**CCW IMPOUNDMENTS
INSPECTION REPORT**

**MITCHELL POWER PLANT
MARSHALL COUNTY,
WEST VIRGINIA**

**PROJECT NO. 09-4157
OCTOBER 2009**

**TRANSMITTAL
ASSESSMENT OF DAM SAFETY OF
COAL COMBUSTION SURFACE IMPOUNDMENTS
DRAFT INSPECTION REPORT
SITE 24 (MITCHELL)**

CONNER RUN DAM
2009 Slope Stability Analysis

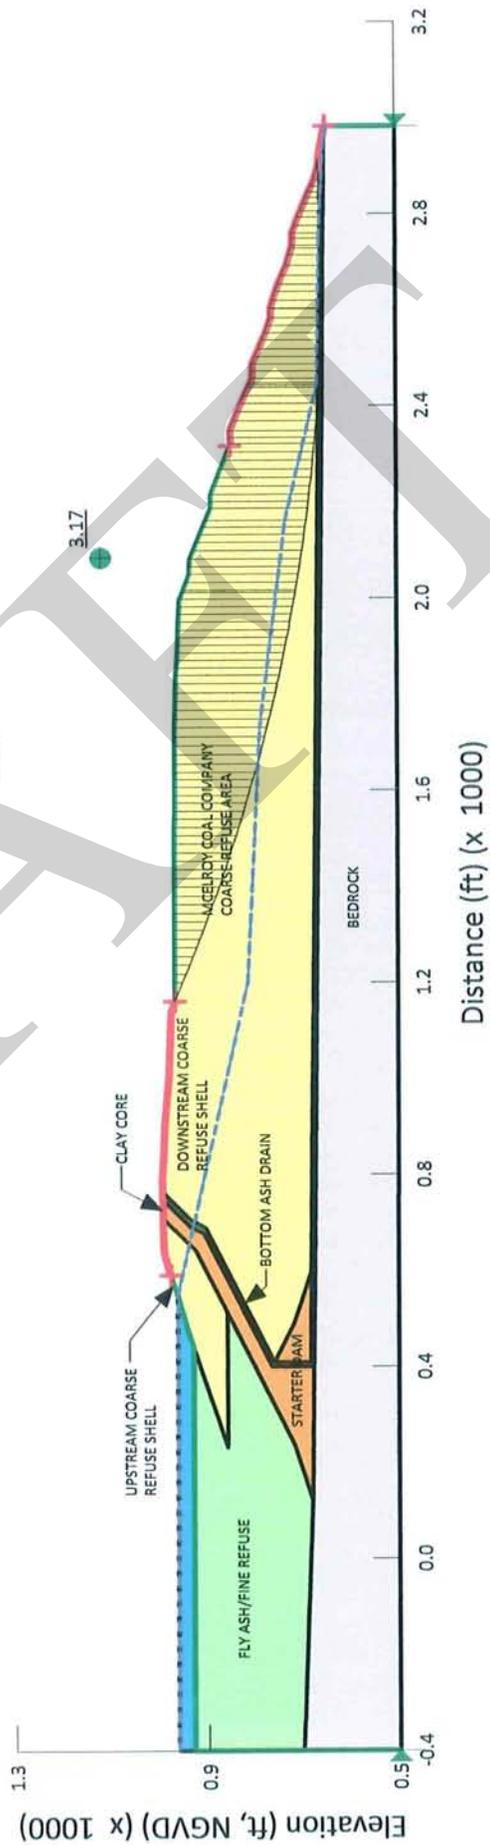
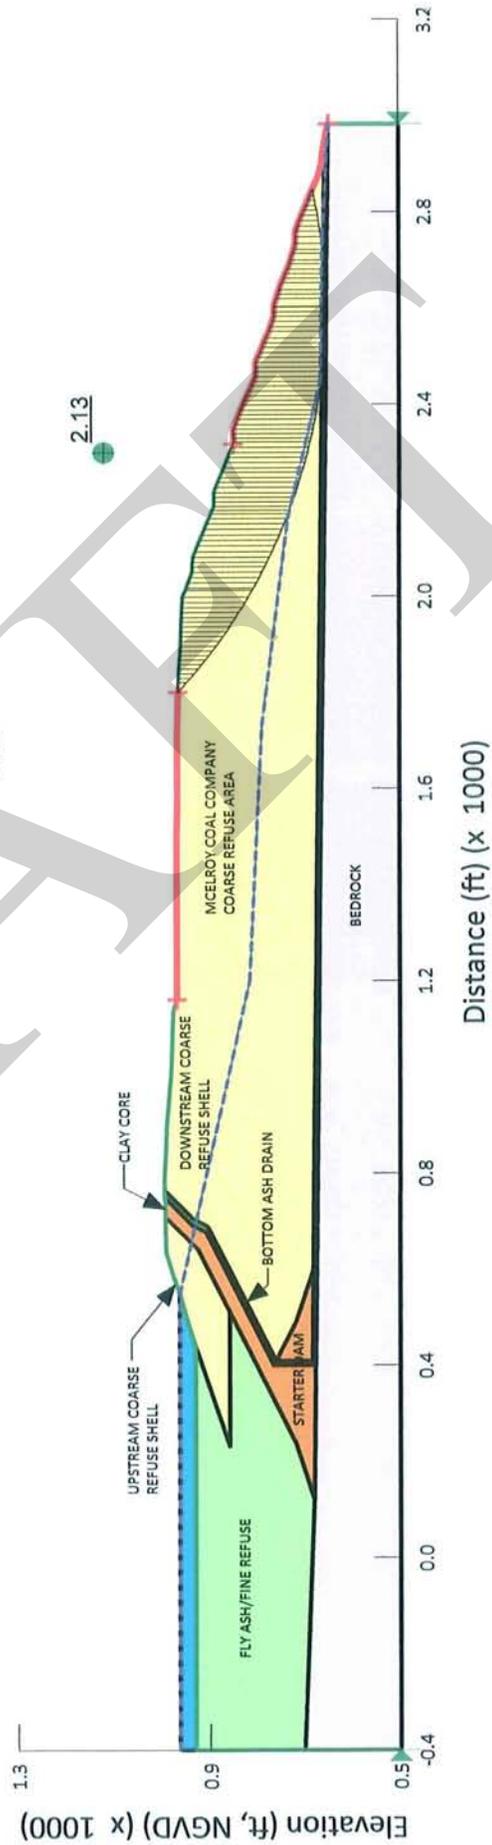
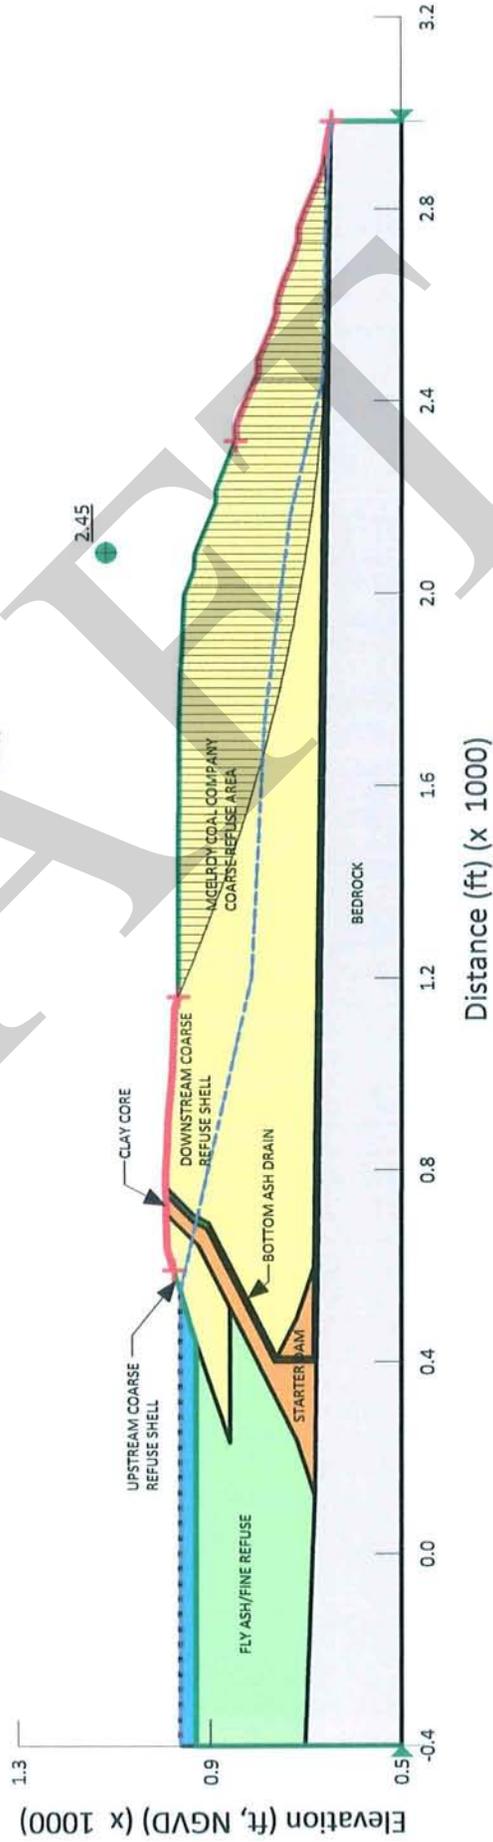
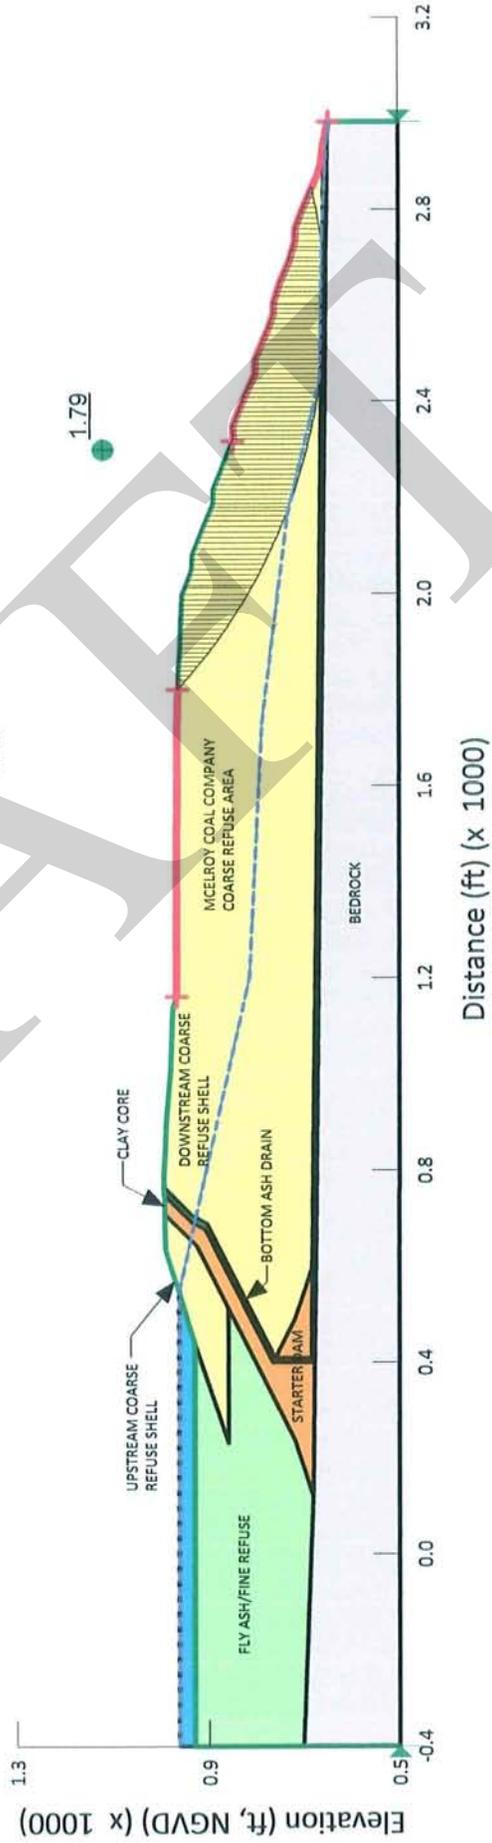
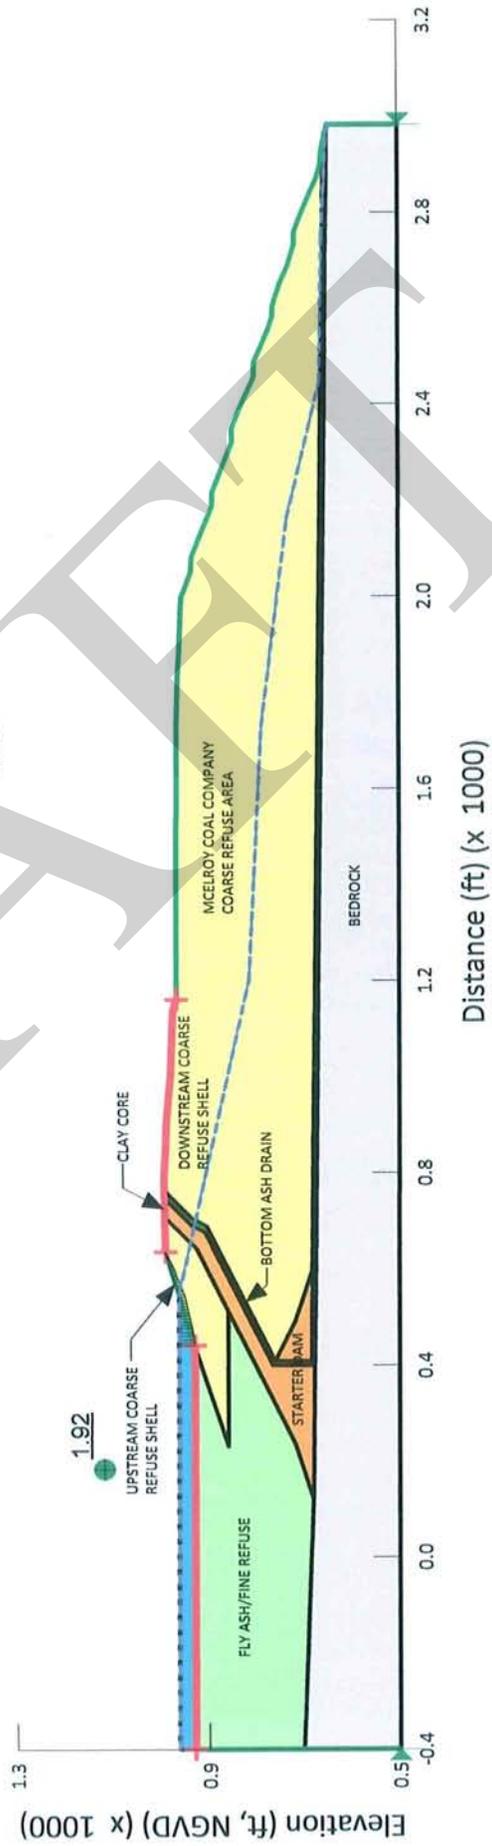
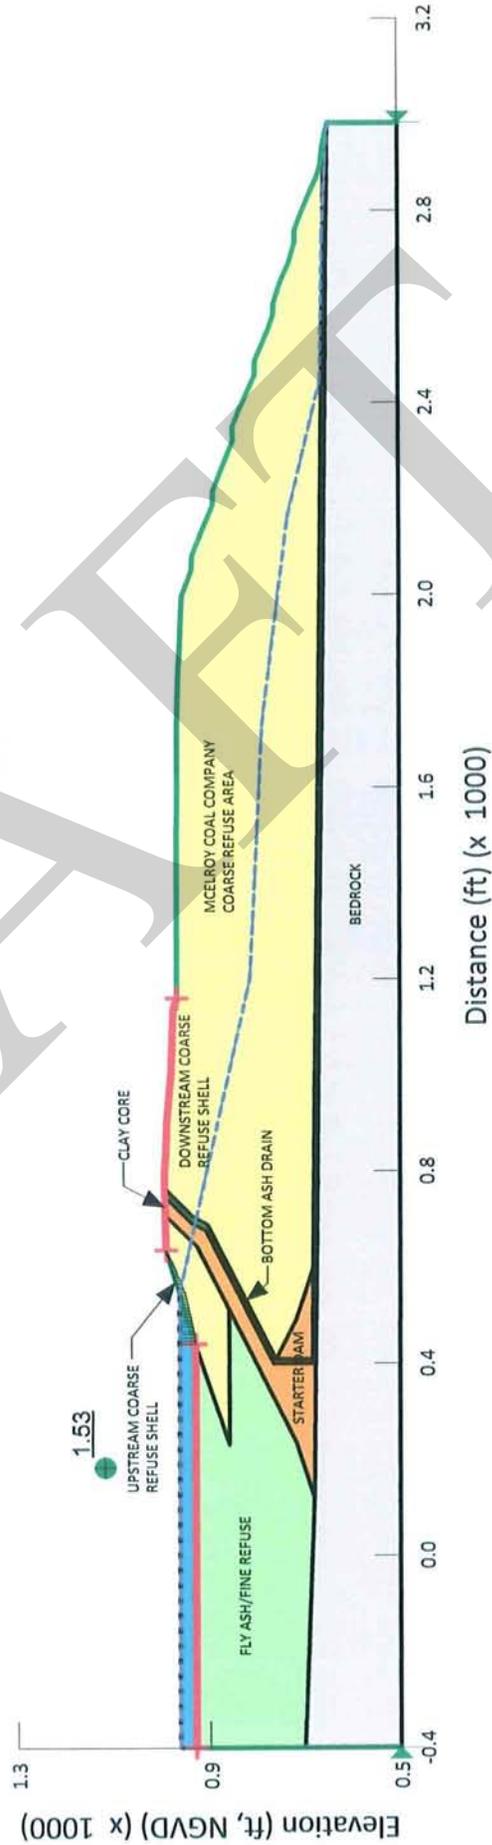
The results show that for the main embankment the required factors of safety are exceeded for all load cases. On the upstream slope, however, RIZZO is not certain if a deeper failure plane, which passes through the fly/ash, was analyzed in the 2009 analysis.

CONNER RUN DAM
2006 Slope Stability Analysis

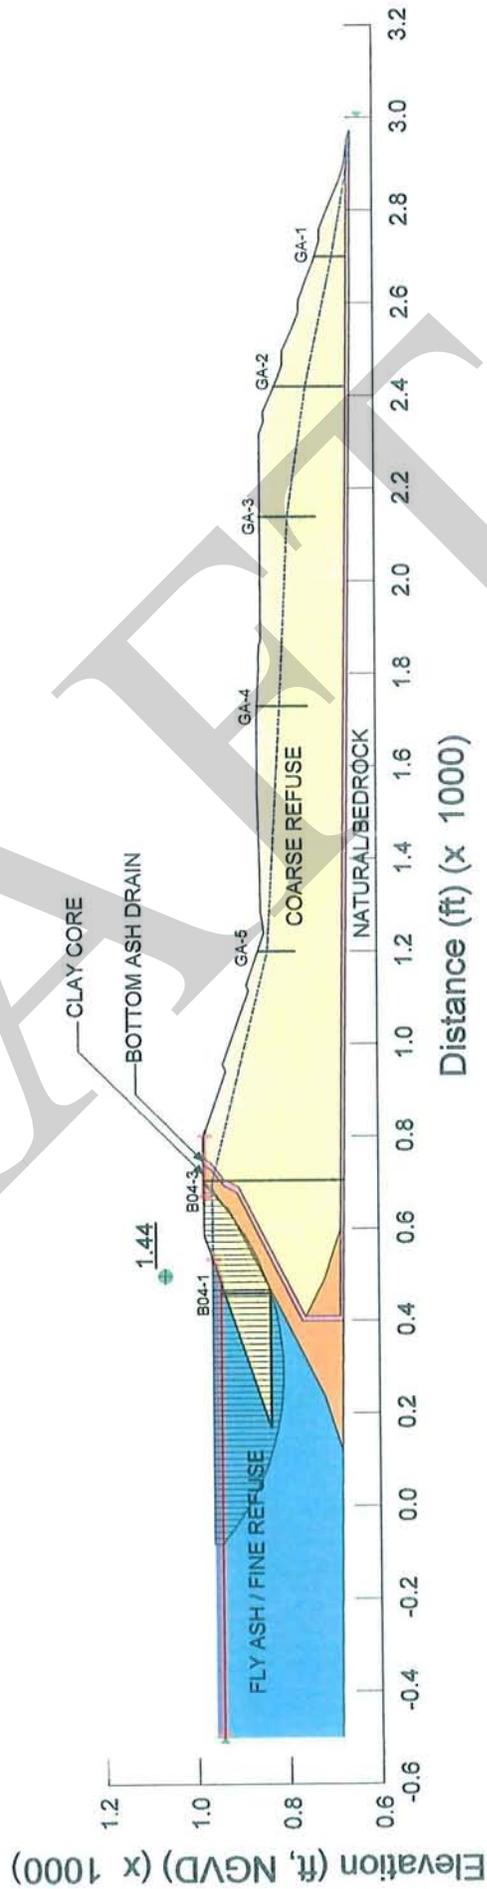
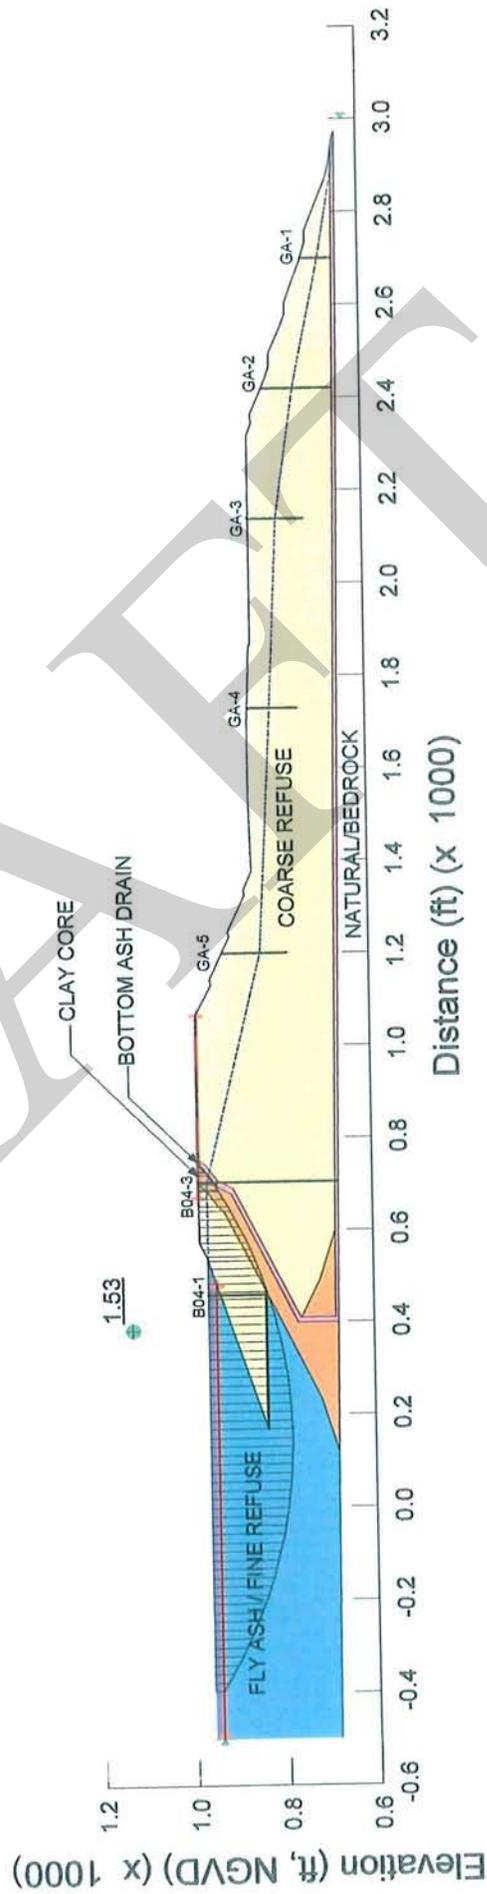
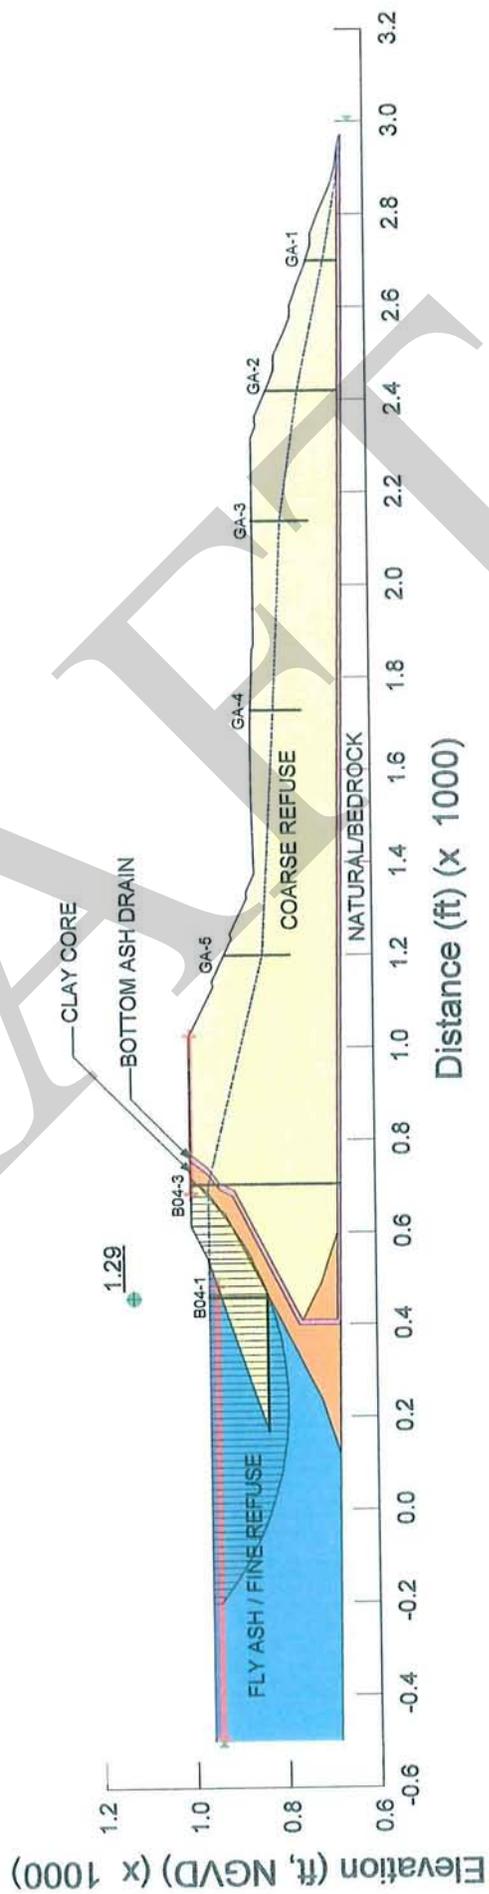
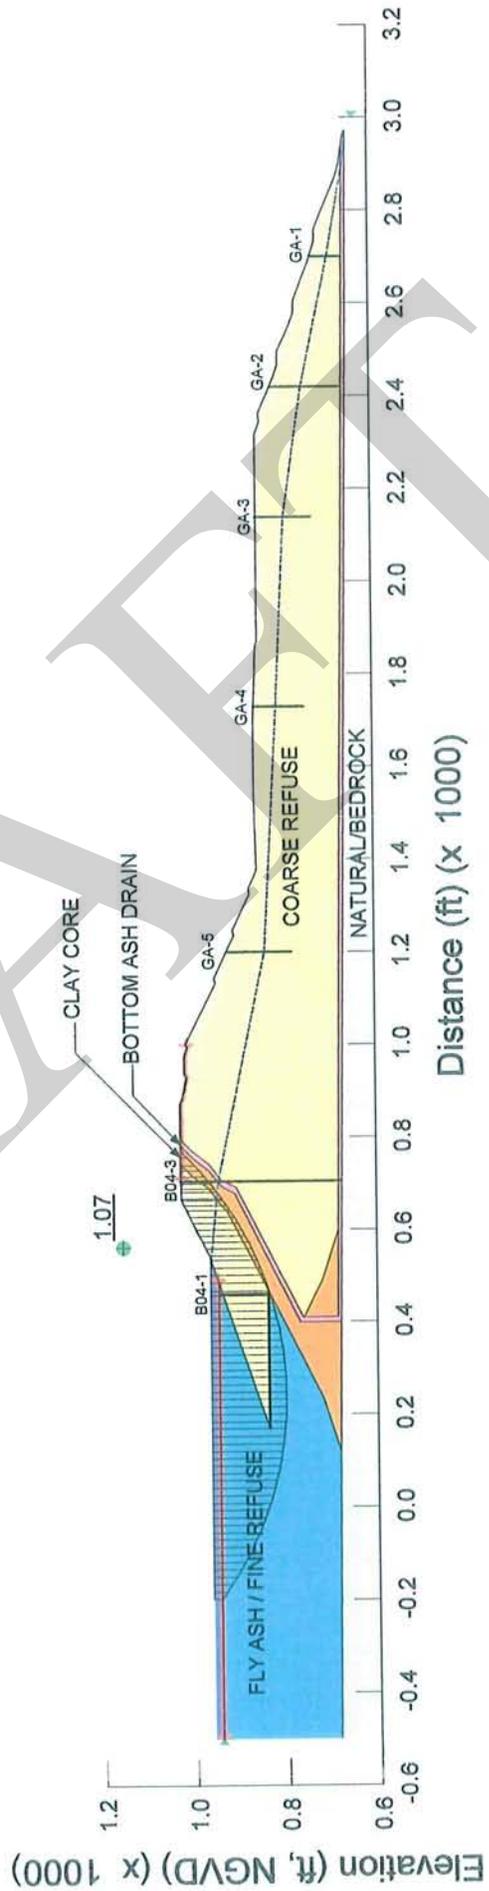
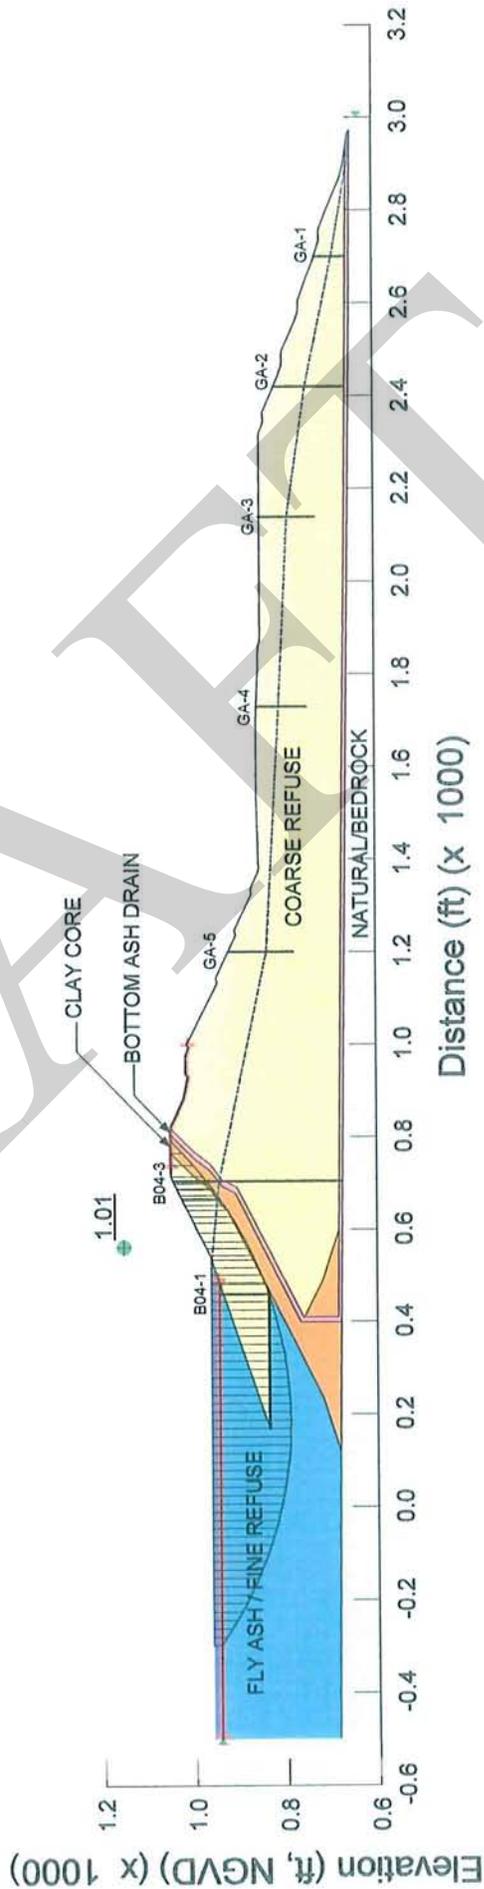
The results of the analyses show a minimum factor of safety of 1.01 for the upstream slope for liquefaction conditions. However, it should be stated that a recent assessment of the fly ash material from a lab analysis performed by Ohio State University indicated that the material is not susceptible to liquefaction during the design seismic event. In addition, field vane shear tests that were performed on fly ash from the bottom of borehole B04-1 yielded a remolded strength exceeding 200 psf.
